FIELD SAFETY NOTICE***Arjo Carevo shower trolley***

Date:	dd-mmm-2026
Product Issue:	Carevo shower trolley torsion spring defect that may increase likelihood of incomplete handle locking potentially contributing to side support opening.
Affected Product:	The scope of potentially affected products includes all Carevo devices manufactured between 01-Aug-2025 – 29-Oct-2025
Resolution:	Reminder of the warnings already included in the Instructions for Use (IFU) supplied along with the device. Torsion spring replacement in affected devices to eliminate the identified contributing factor to unintentional side support opening.
Field Safety/Correction Notice:	FSN_2980188-3
Pages:	6 & Customer Response Form
Single registration number of the manufacturer:	SE-MF-000000696

Pic. 2 Latches in the correct and incorrect locked position and their location on the device (actual device photo vs. illustration from IFU)

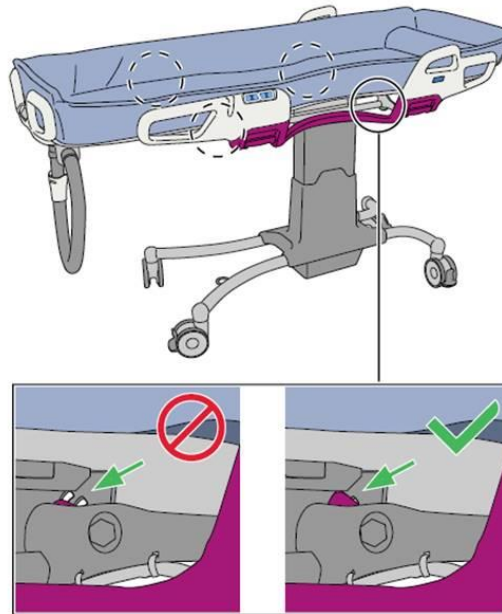
2. **Ensure both latches on each side support are in the locked position.** Failure to comply may result in unintentional side support opening while handling a patient/resident, posing their fall risk. Refer to picture 2.

Pic. 3. Warning regards to knee hitting the handle.

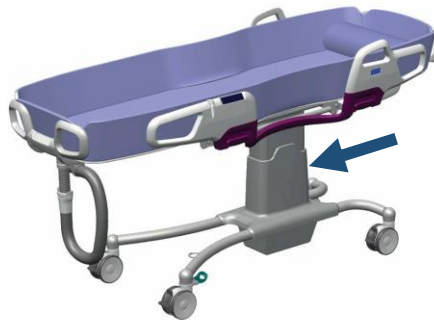
3. **Avoid hitting or pushing the side support handle with your thigh or knee when handling the patient.** Failure to comply may result in unintentional side support opening while handling a patient, posing a fall risk. Refer to Pic.3.
